**Application for Planning Permission under Section 16 of Town Planning Ordinance
(Cap. 131) for Renewal of Planning Approval for Temporary Educational Institution
(Teaching Farm) for a Period of 3 Years
(Planning Application No. A/NE-LT/788)**

Submission of Further Information

Response-to-Comment Table

Photos of additional mitigation measures

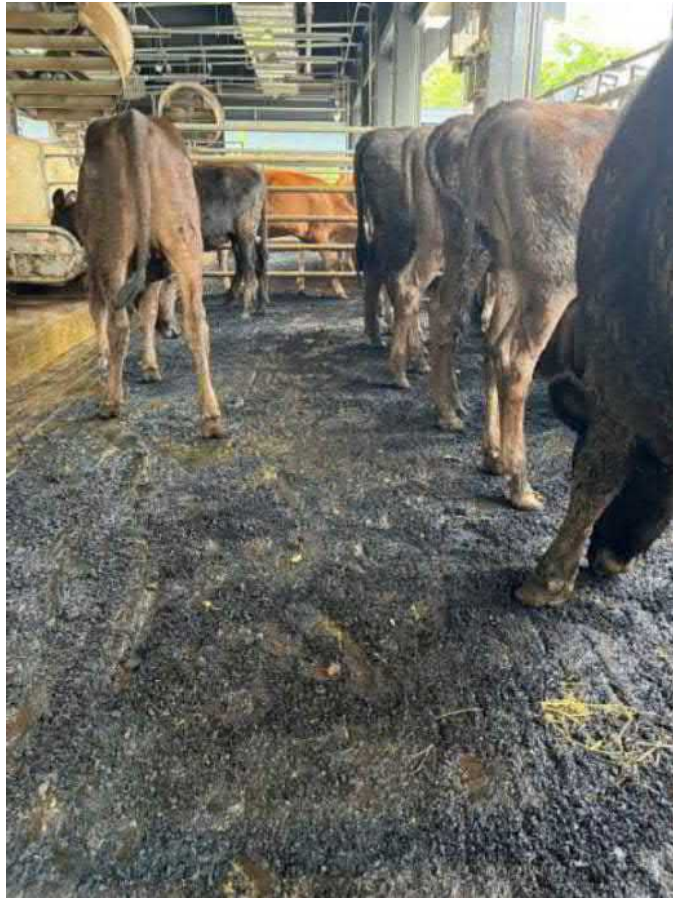
| No. | Comments | Responses |
|-----|--|---|
| 2. | <p>Environmental Protection Department, Environmental Assessment Division, Territory North Group, Sheung Shui, Fanling, Tai Po, dated 10 April 2026</p> <p>We note that a substantiated odour complaint from the vicinity of the site was recorded by our enforcement team in mid-2025. With a view to</p> | |

| No. | Comments | Responses |
|-----|---|---|
| | <p>understanding the current situation, we would be grateful if the applicant could advise:</p> <p>(i) whether any additional measures have been proposed to mitigate the odour impacts in view of the complaint (e.g. any additional operational procedures like waste handling frequency, manure storage arrangements, cleaning protocols). For clarity and ease of reference, please set out the mitigation measures under two categories: (1) Measures as originally approved under Application No. A/NELT/662; and (2) Any additional measures subsequently implemented in response to the odour complaint and their effectiveness</p> | <p>1) Measures as originally approved under Application No. A/NELT/662</p> <p>Please be advised that the odour control measures as mentioned in Application No. A/NELT/662 are:</p> <p><u>a. Para# 3.6.6 and 3.7.4</u></p> <p>i) Manure collected by operator and stored in underground manure scrape pits with stainless steel cover</p> <p>ii) Regular cleaning by operator</p> <p>iii) Produced wastewater to be diverted to manure scrape pits and collected by tanker twice a week</p> <p><u>b. Para# 3.8.3</u></p> <p>A ventilation system will be installed in order to extract the odour smell in the barns. Exhaust fan will be installed on the rooftop of adult barn and young livestock barn.</p> <p><u>c. Para# 3.8.4</u></p> <p>i) Inspection of the ventilation system and activated carbon filters</p> <p>ii) Spare parts such as air duct, exhaust fan and activated carbon filters will be stored on-site</p> <p><u>d. Para# 3.8.5</u></p> <p>i) Scheduling the wastewater collection period in less sensitive hours</p> <p>ii) Collecting wastewater on a regular basis to avoid excessive amount of collection</p> <p>iii) Properly arranging the route of collection process to reduce the time for collection</p> |

| No. | Comments | Responses |
|-----|----------|--|
| | | <p>iv) Carefully installing the pipes into the sewage holding tank and manure scrape pits to avoid potential leakage</p> <p>v) Cleaning the leakage once observed during the collection process</p> <p>vi) Closing any opening of the sewage holding tank and manure scrape pits after the collection</p> <p>vii) Ensuring the pipe at vacuum tanker placed properly prior to leaving the site</p> <p>The above odour control measures are complied with since the operation of CityUHK Farm.</p> <p>2) Any additional measures subsequently implemented in response to the odour complaint and their effectiveness</p> <p>On top of the odour control measures mentioned in Application No. A/NELT/662, the following additional measures are implemented in response to odour complaint:</p> <p>a. Biochar: Application to floors</p> <p>CityUHK Farm has worked on the use of biochar, produced at EcoPark at Tuen Mun. Biochar is highly absorbent, nearly as much so as activated charcoal, and absorbs ammonia and other malodorous sulphur containing manure gases at source when spread on the floor.</p> <p>The biochar is applied twice a day when the cows are out of their pens for milking. Increasing the amount of biochar applied is more effective than increasing the frequency of application, as an increased application amount provides greater surface area for absorption of malodourous gases and alkalizes the cattle manure more, hence reducing bacterial degradation and production of gases. We will increase the application rate of biochar during the wet season in 2026,</p> |
